**PLANNING COMMISSION REPORT
REGULAR AGENDA -- PUBLIC HEARING ON VARIANCE REQUESTS ONLY**

PC Staff Report
07/22/2009

**ITEM NO. 7: PRELIMINARY PLAT FOR FIFTH STREET BLUFF SUBDIVISION
(MKM)**

PP-04-01-08: Consider the Preliminary Plat and variances related to dedication of rights-of-way and frontage for Fifth Street Bluff Subdivision, 0.29-acre subdivision consisting of one lot, located at 427 Country Club Court (W. 5th St east of Iowa St.). Submitted by JMC Construction, Inc., property owner of record. *City Commission referred back to the Planning Commission on 6/23/09 for consideration of variances to dedication and frontage requirements.*

Figure 2. The proposed lot, outlined in red, is compatible with the size and shape of existing lots in the area.

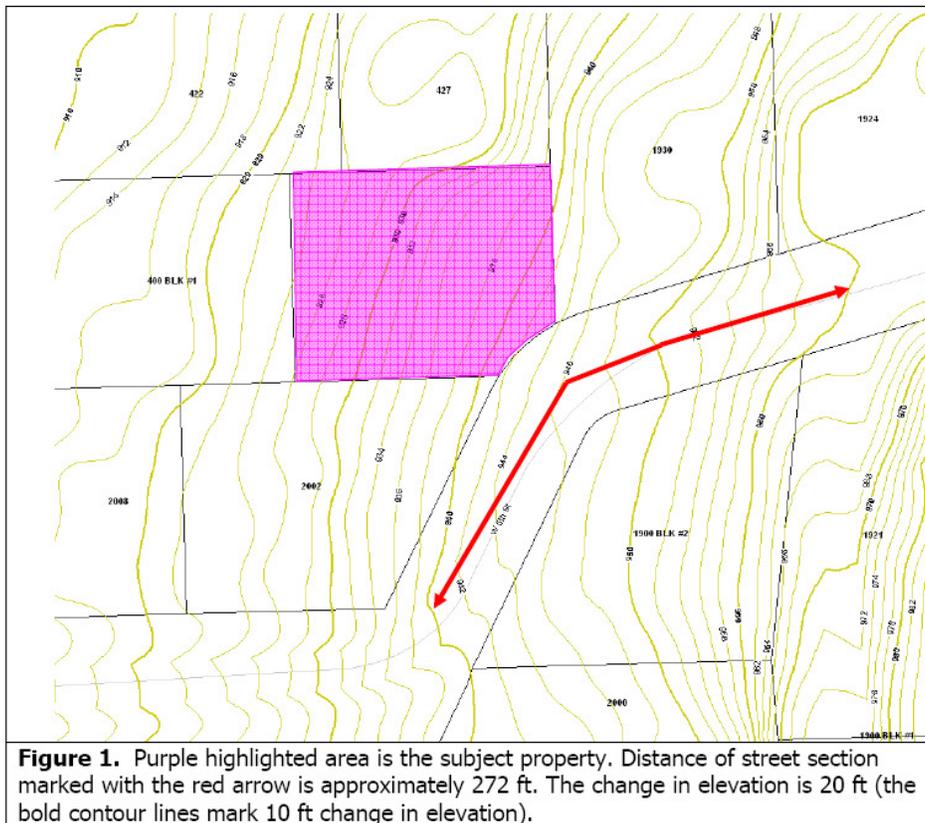
Horizon 2020 recommends that the character and appearance of existing low-density residential neighborhoods should be protected through compatible infill development. This plat creates a 12,702 sq. ft. lot. Nearby lots are within the 10,700 sq. ft. to 17,194 sq. ft. range. (See Figure 2) The lot being created with this plat is compatible with the existing lots.

Figure 3. The red hatchmarks along the street frontage indicate the amount of street frontage that is required in the RS10 District. The variance is being requested to permit the frontage to vary below the minimum as shown on the plat.

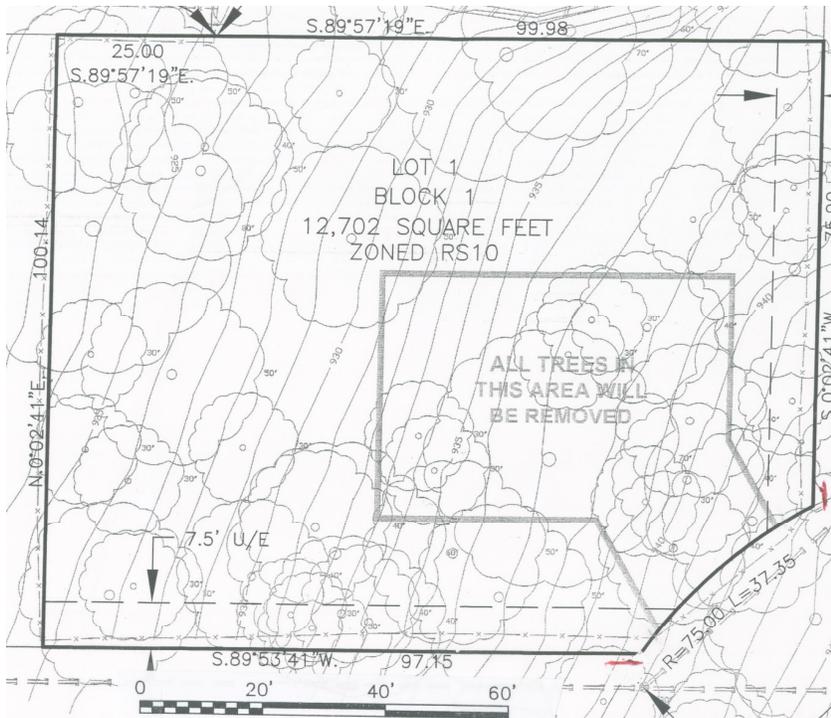
The property is zoned RS10 which permits lots with a minimum lot area of 10,000 sq. ft. Other requirements for lots within the RS10 District are listed in Section 20-601 of the Development Code are as follows: Minimum Lot Width – 70'; Minimum Lot Frontage – 40 ft; Minimum Setbacks – 25 ft. front, 10 ft side and 25 ft rear; Maximum Building Cover – 40% of site; and Maximum Impervious cover --- 70% of site. The setbacks, building cover and impervious cover will apply to this property as it was platted after the effective date of the Subdivision Regulations and will be addressed at the building permit stage. The minimum lot width and frontage are dimensions that are established with the plat. Lot Width is defined in Section 20-1701 of the Development Code as 'the distance between side lot lines measured at the point of the required front setback or chord thereof'. The lot width of the proposed lot is approximately 80' measured at the front setback line if an additional 5' of right-of-way is dedicated. ***Without the additional right-of-way, as shown on the June 27 revised plat, the lot width is approximately 78 ft..*** The lot frontage is approximately 45' when the additional 5' of right-of-way is considered. ***Without the additional right-of-way, the lot frontage is 37.35 ft. As the City Commission did not accept the dedication of the additional right-of-way, the lot frontage provided is less than the 40 ft minimum required in the RS10 Zoning District. The applicant is therefore requesting a variance from the requirement in Section 20-810(a)(2)(i) to permit a lot to be designed with less than the minimum required frontage. The variance is discussed in a later section of this staff report.***

MINIMUM LOT FRONTAGE: The proposed lot frontage, 37.35 ft, is 2.65 ft less than the minimum 40 ft of frontage which is required for the RS10 Zoning District. (Figure 3) The variance will allow for infill development which is compatible with the existing neighborhood. The variance is in harmony with the intended purpose of the Subdivision Regulations.

STAFF RECOMMENDATION: Staff recommends approval of the following variances:

- 1) From Section 20-810(d)(4)(i) which requires 60 ft of right-of-way for local streets to permit the right-of-way to remain at 50 ft in this location.***
- 2) From Section 20-810(a)(2)(i) which requires that lots be designed to comply with all applicable zoning district regulations to permit the creation of a lot with 37.35 ft of frontage in the RS10 Zoning District.***
